ADDENDUM

NO. 2

PROJECT NAME: AR Turner Elementary School Classroom Expansion

ADDENDUM DATE: Thursday, July 23, 2026

AD No 2, Civil Item 1: To the Drawings, Sheet C1.06, "SITE & DIMENSION CONTROL PLAN,"

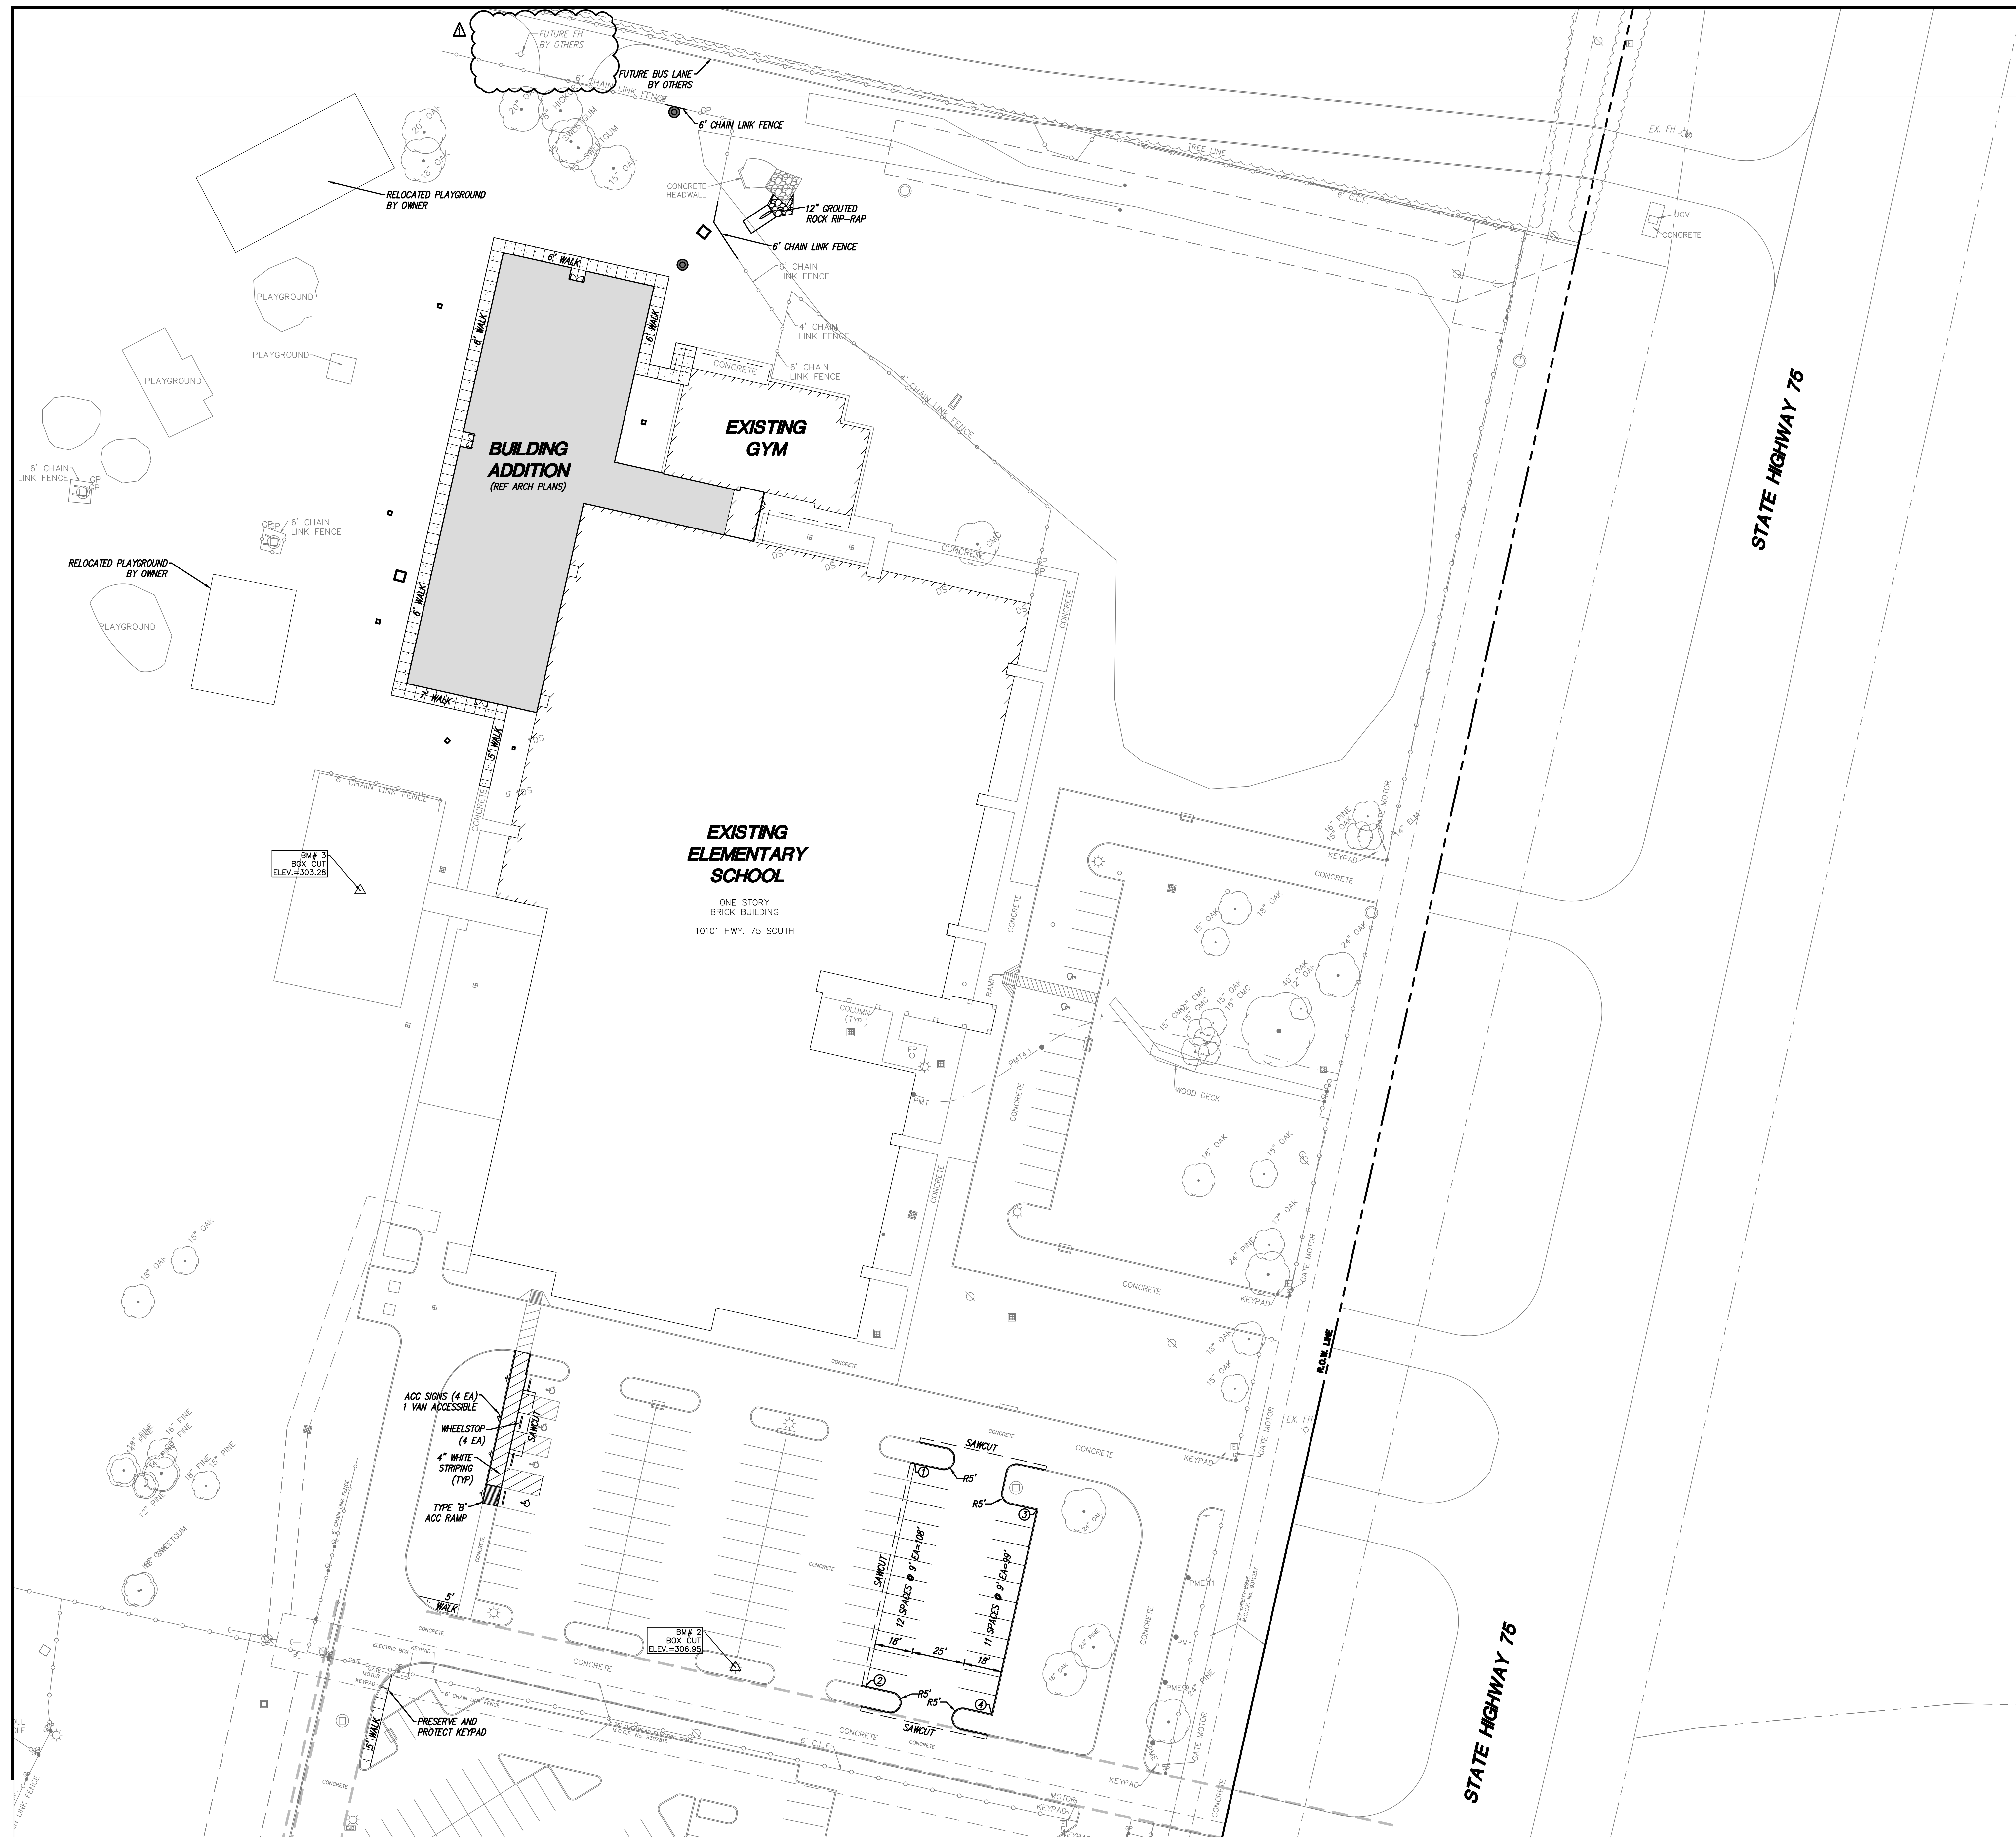
- 1) Future fire hydrant by others added to drawing.

AD No 2, Land Item 1: **To the Drawings, Sheet L1.01, "LANDSCAPE PLAN,"**

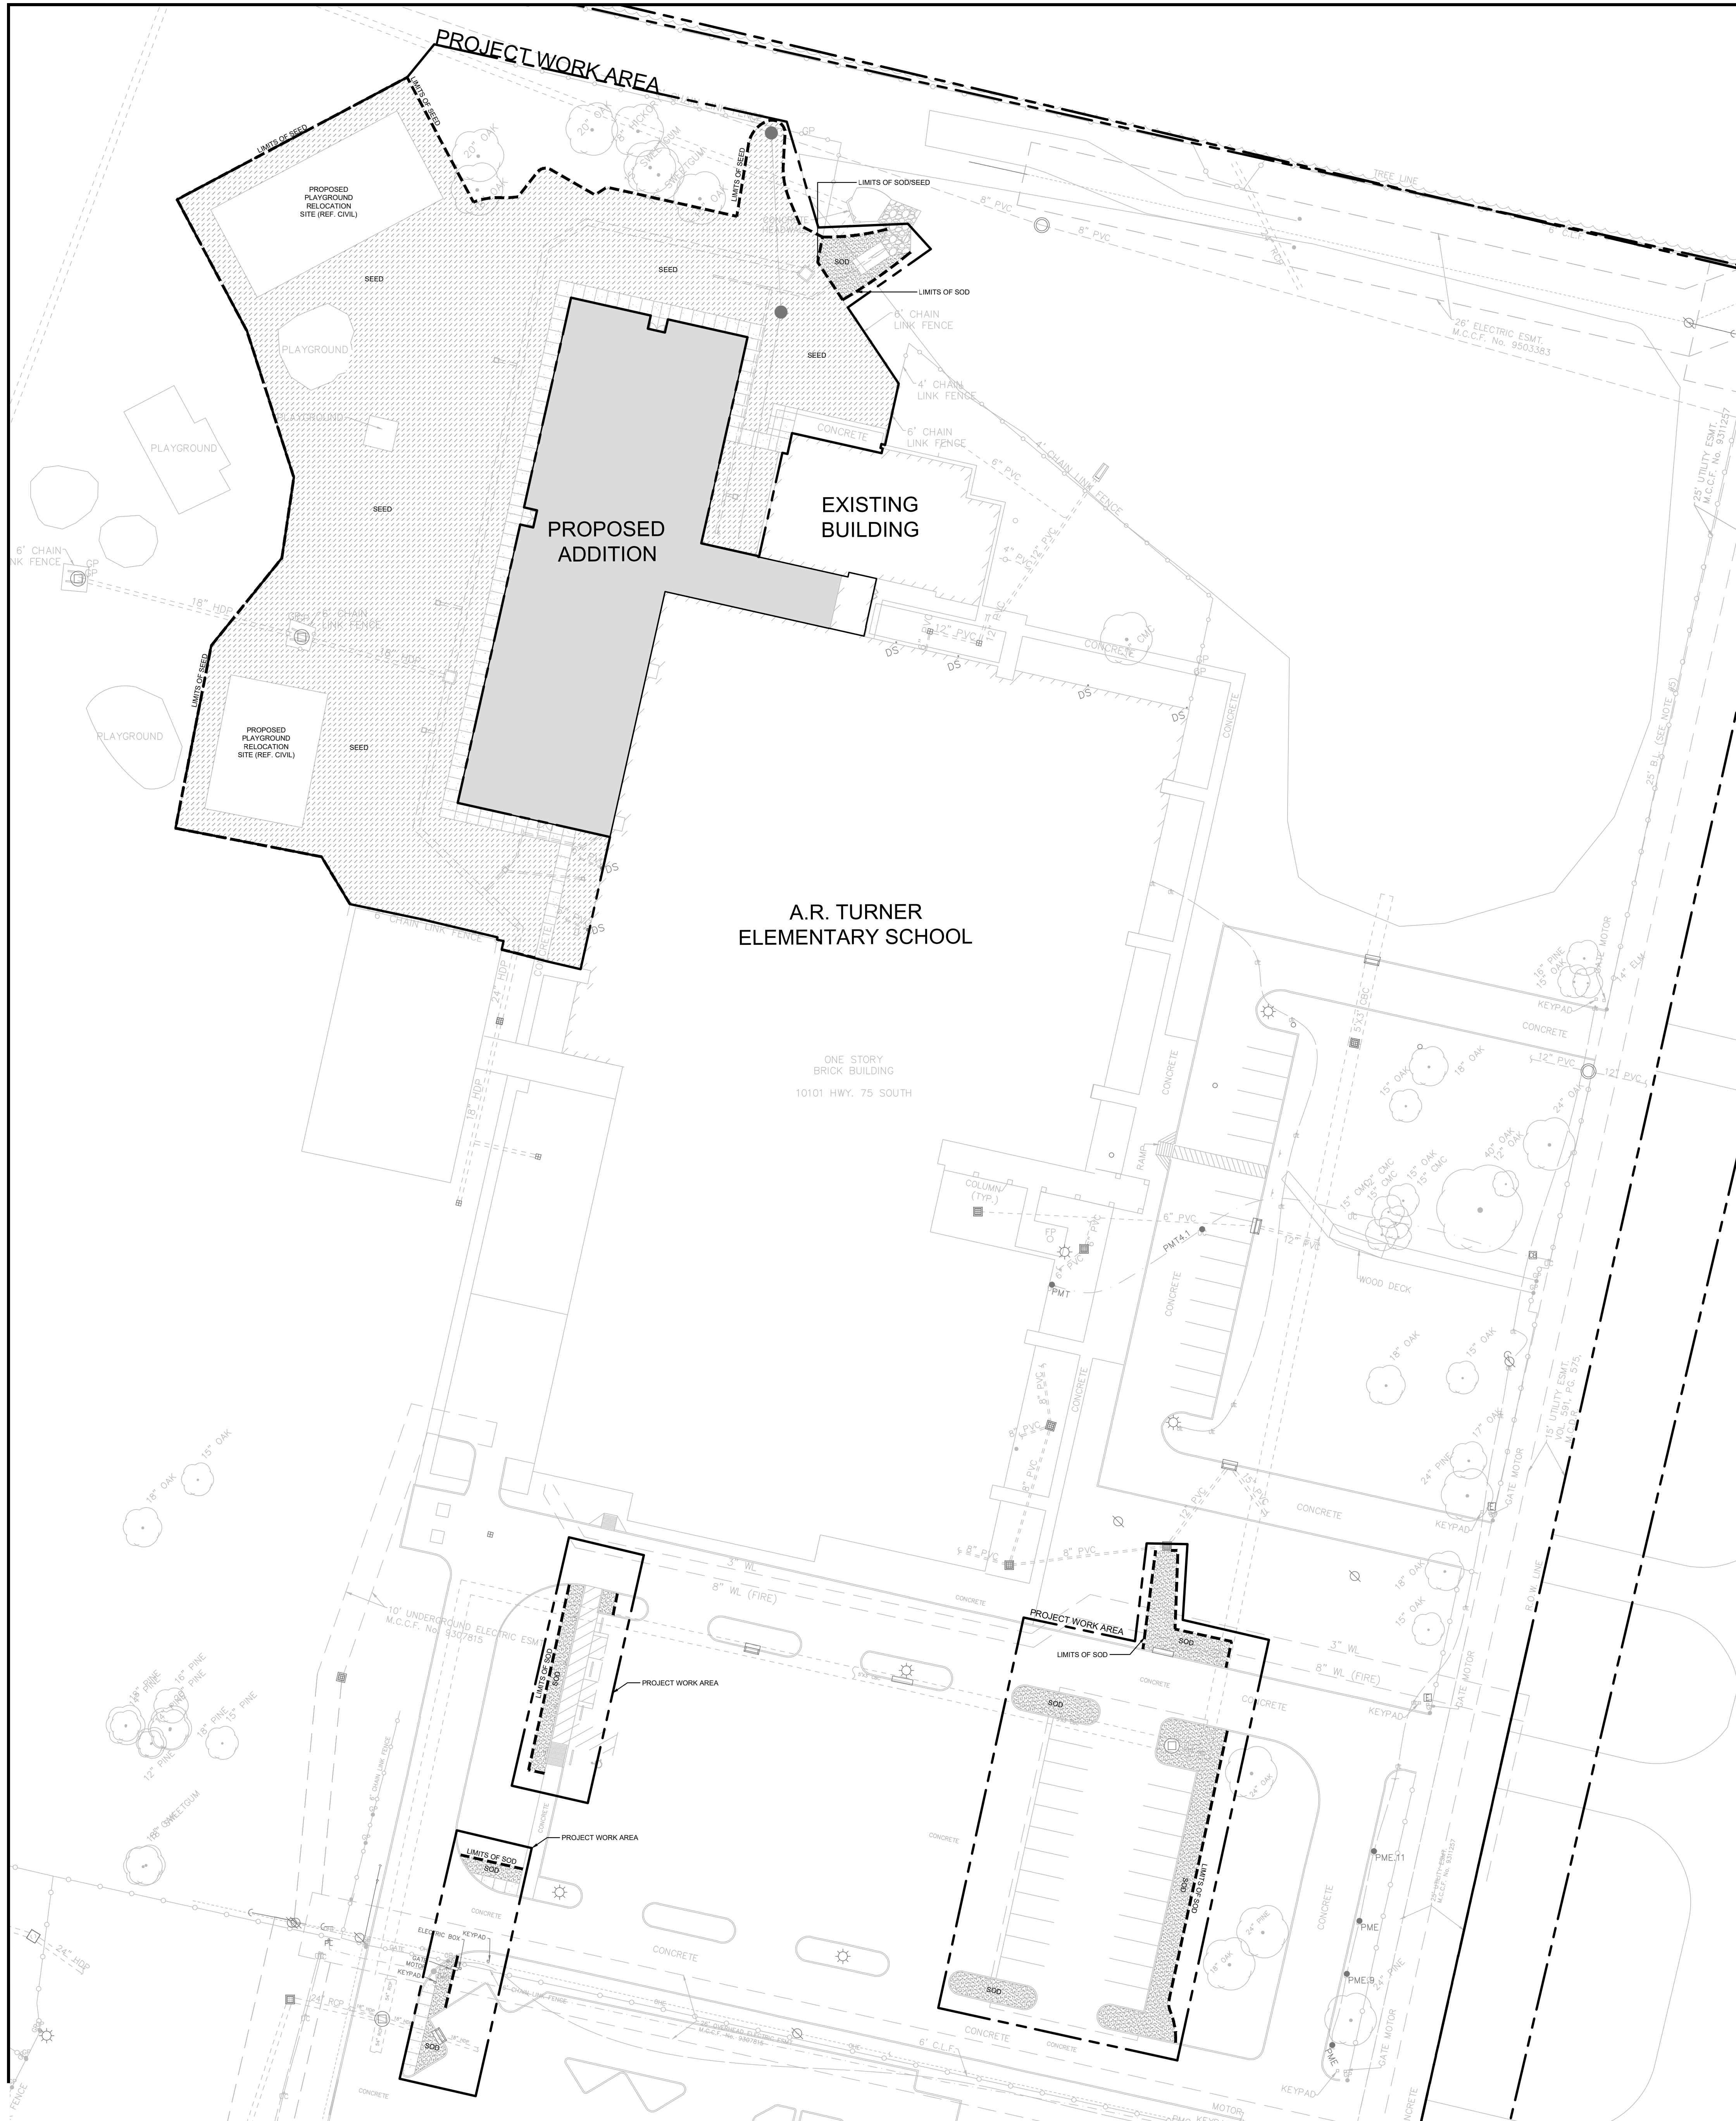
- 1) Added backflow device detail for temporary irrigation.
